## **THE PRESERVE SUBDIVISION, PHASE 1**

APPLICATION NUMBER 7 DATE April 5, 2018

# DETAIL SITE PLAN

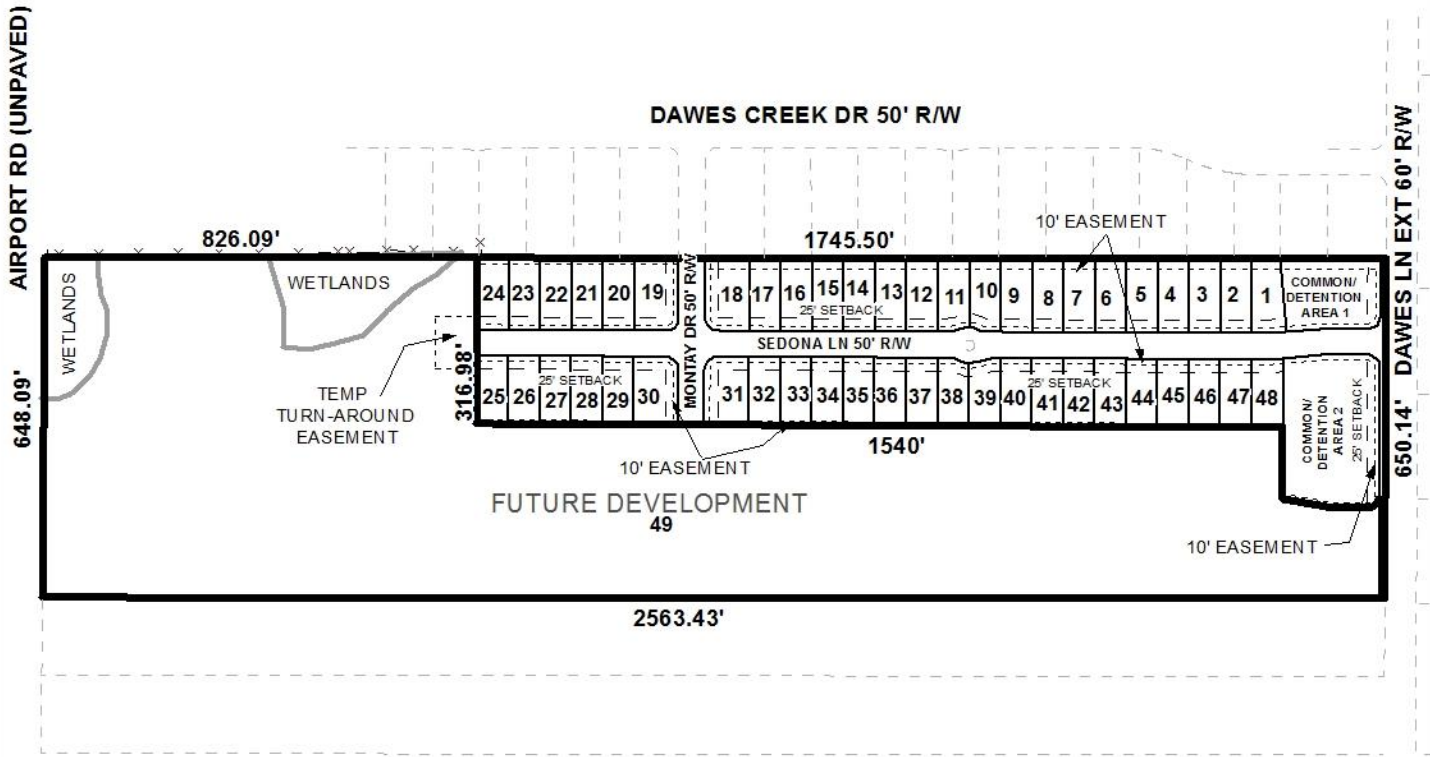
The site has frontage along Dawes Lane Extension, a paved minor street with ribbon curb and gutter. As a minor street, this street requires a 50' right-of-way width according to the Major Street Plan component of the Comprehensive Plan. The preliminary plat illustrates Dawes Lane Extension as having a 60' right-of-way width and, if approved, should be retained on the Final Plat. The site also fronts Airport Road, a proposed major street per the Major Street Plan. As a major street, Airport Road requires a 120' right-of-way width. The preliminary plat does not provide the right-of-way width of Airport Road. If approved, the Final Plat should illustrate a minimum right-of-way width of 60' as measured from the centerline along Airport Road. The subdivision should be denied access to Airport Road until it is improved with asphalt or concrete to County Engineering standards.

The 25' minimum building setback lines are depicted on the plat and if approved, should be retained on the Final Plat.

The lot sizes are labeled in square feet and acres with the largest lot proposed to be 11,697 square feet and the smallest lot to be 7, 599 square feet with all lots roughly being 60' in width and 120' to 140' in length, thus meeting the size requirements and depth to width ratio

requirements. If approved, this information should be retained on the Final Plat or a table should be provided furnishing the same information.

It should also be pointed out that the legal description and preliminary plat include Lots 3 and 4 of "Atchison Estates, Resubdivision of Lot 3," nothing was provided with the application to indicate that the lots were purchased by the applicant, or that the current property owner has authorized the application. If the applicant does not own the lots, and if the property owner has not authorized their inclusion, the current application should be denied.

It should be pointed out that this development is just Phase 1, of multiple possible phases. The current plat identifies Lot 49 as "Future Development". However there is no overall composite plan showing all proposed phases, thus staff has no information regarding the ultimate proposed number of lots, or the total number of access points for the subdivision and overall development.

Based on the preceding, the application is recommended for Holdover to the May 3<sup>rd</sup> meeting so that the following can be addressed:

- 1) an overall plan for The Preserve Subdivision, depicting all proposed phases to be submitted by Monday, April 16<sup>th</sup> ;
- 2) revision of the proposed subdivision to accommodate the proposed Airport Boulevard major street to depict the right-of-way width and dedication as plan required per the major street plan; and
- 3) proof of ownership of Lots 3 and 4 of "Atchison Estates, Resubdivision of Lot 3 by the applicant, or authorization by the property owner to make the application.
